ADDENDUM NO. 5 TO PROJECT NO. 45124

**CONSTRUCTION WORK, HVAC WORK, PLUMBING WORK, AND ELECTRICAL WORK
ABATE HAZARDOUS MATERIALS
AND RENOVATE BUILDING NO. 4
STATE OFFICE BUILDING CAMPUS
1220 WASHINGTON AVENUE
ALBANY, NY**

October 14, 2016

DRAWING NUMBER:
G-008

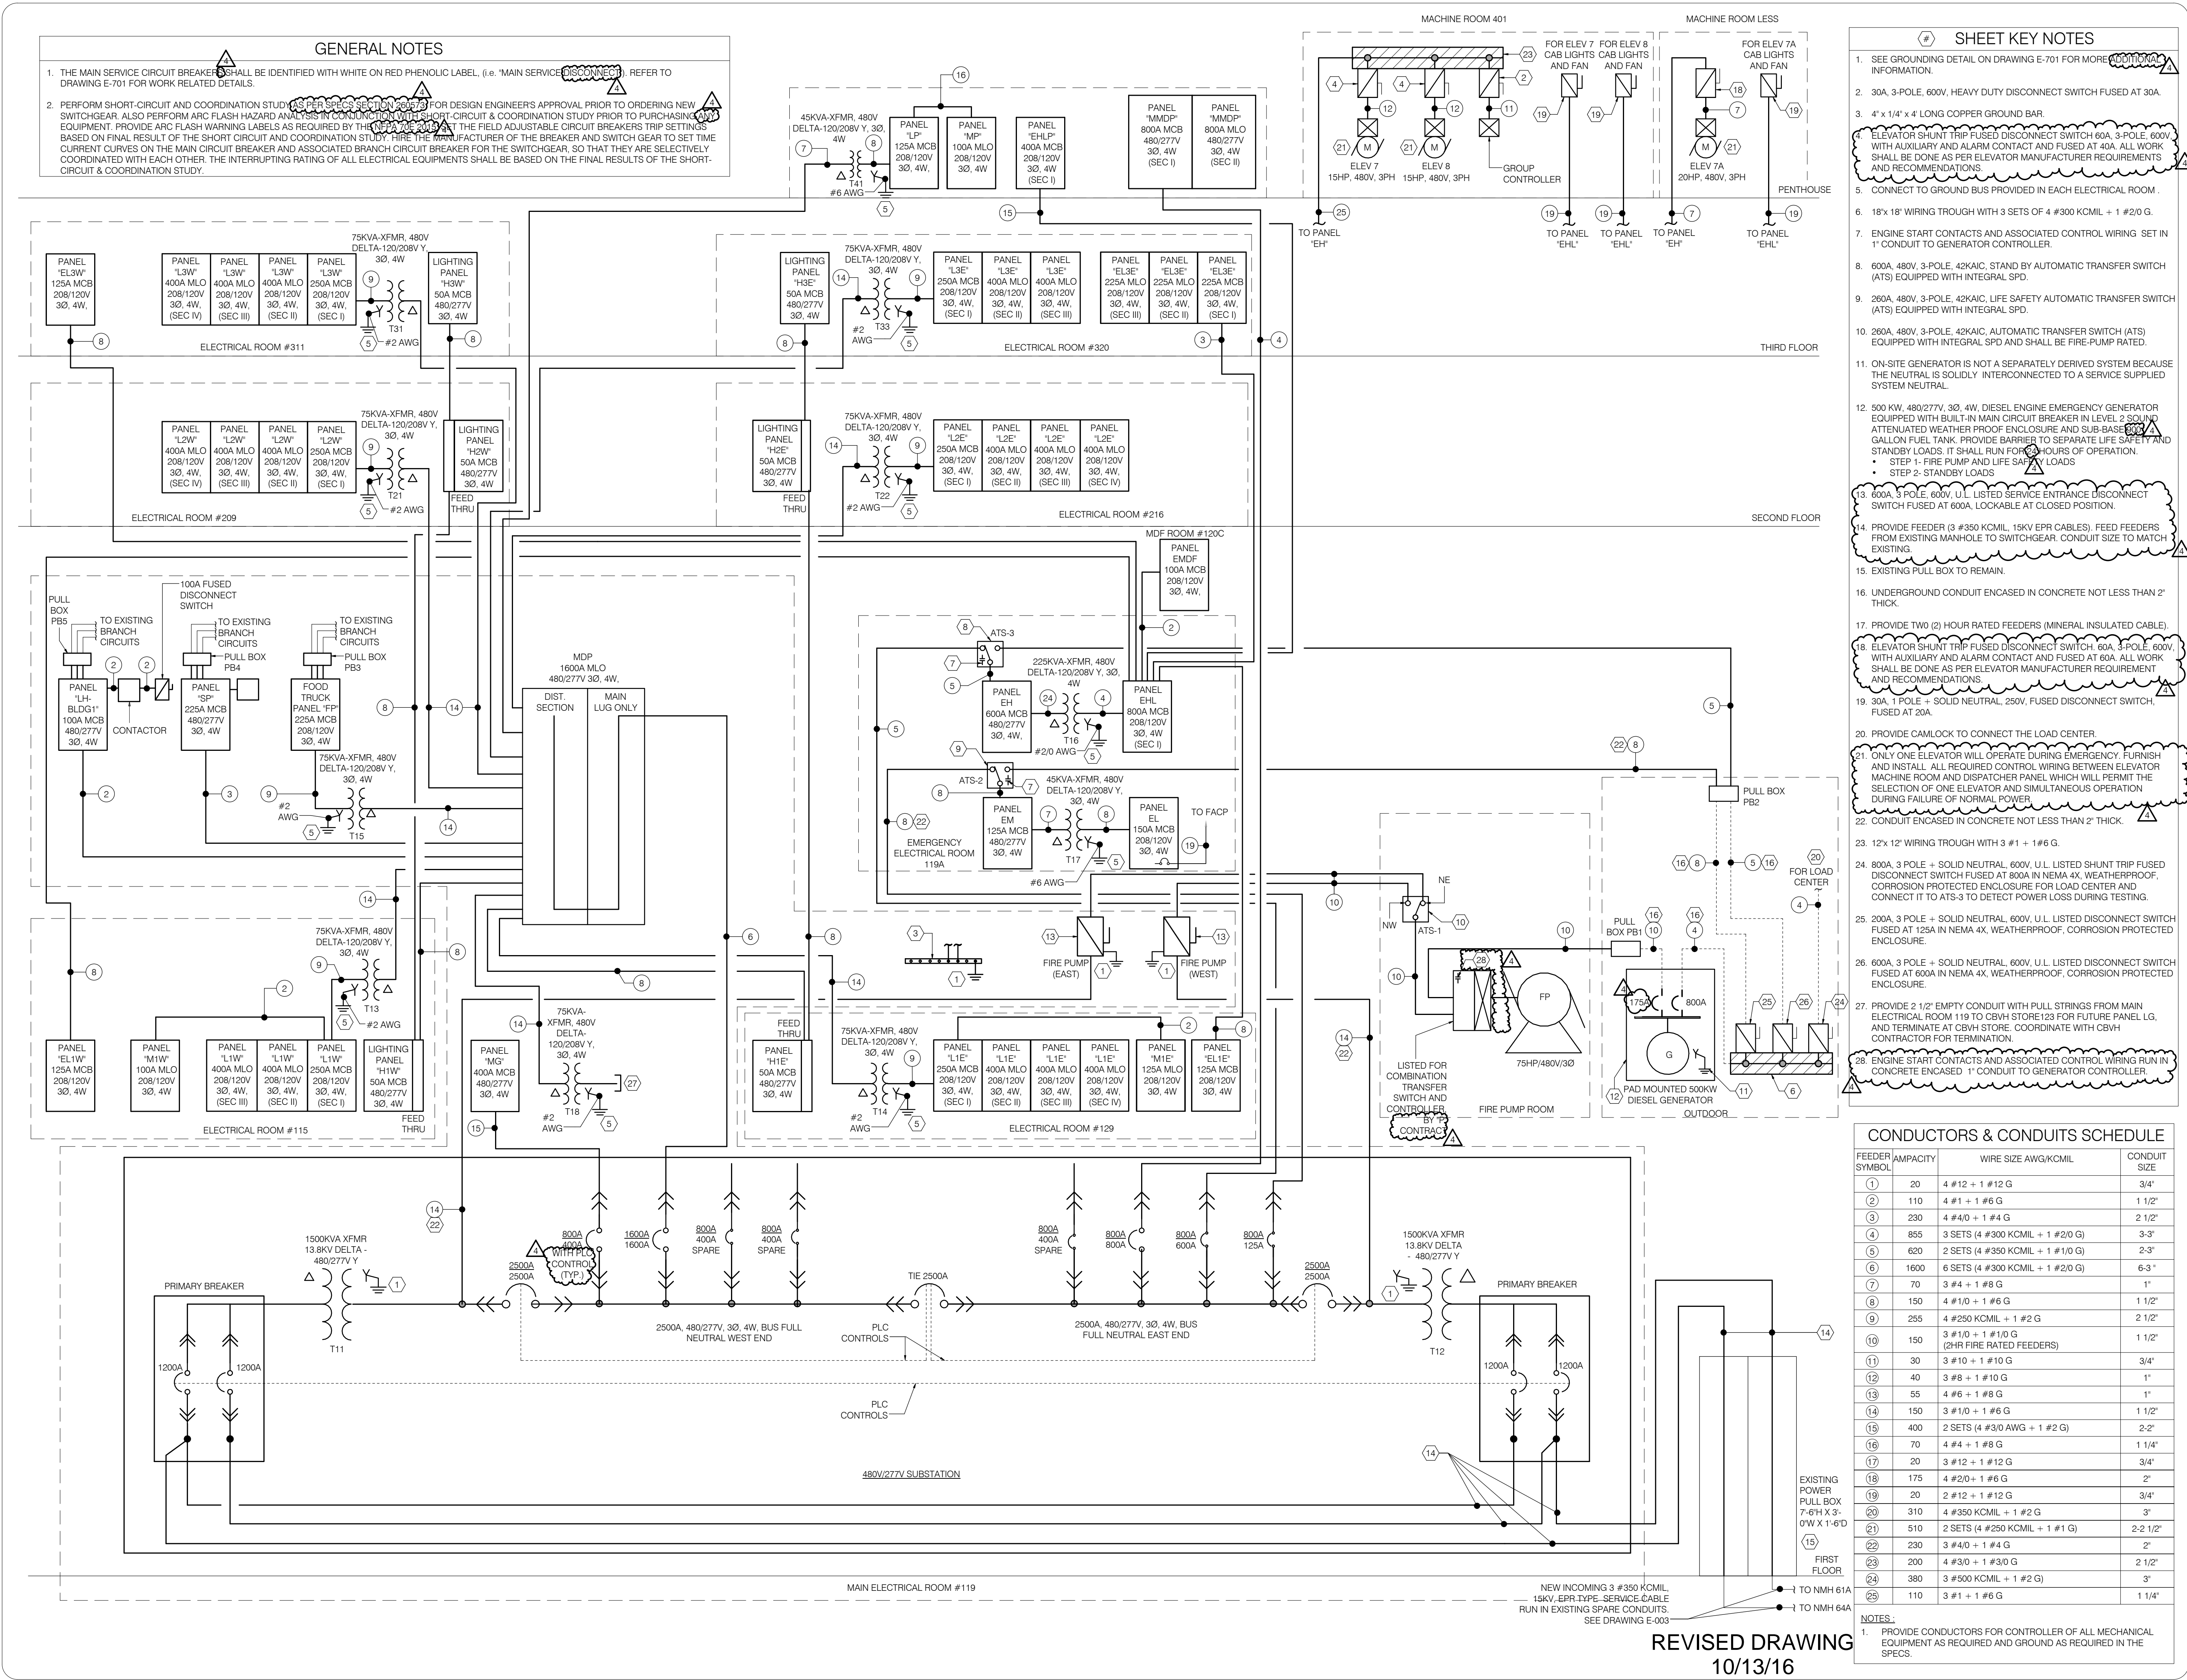
- 32. Addendum Drawings:
 - a. Drawing No. G-008 noted “ADDENDUM DRAWING 10/13/16” accompanies this Addendum and forms part of the Contract Documents.
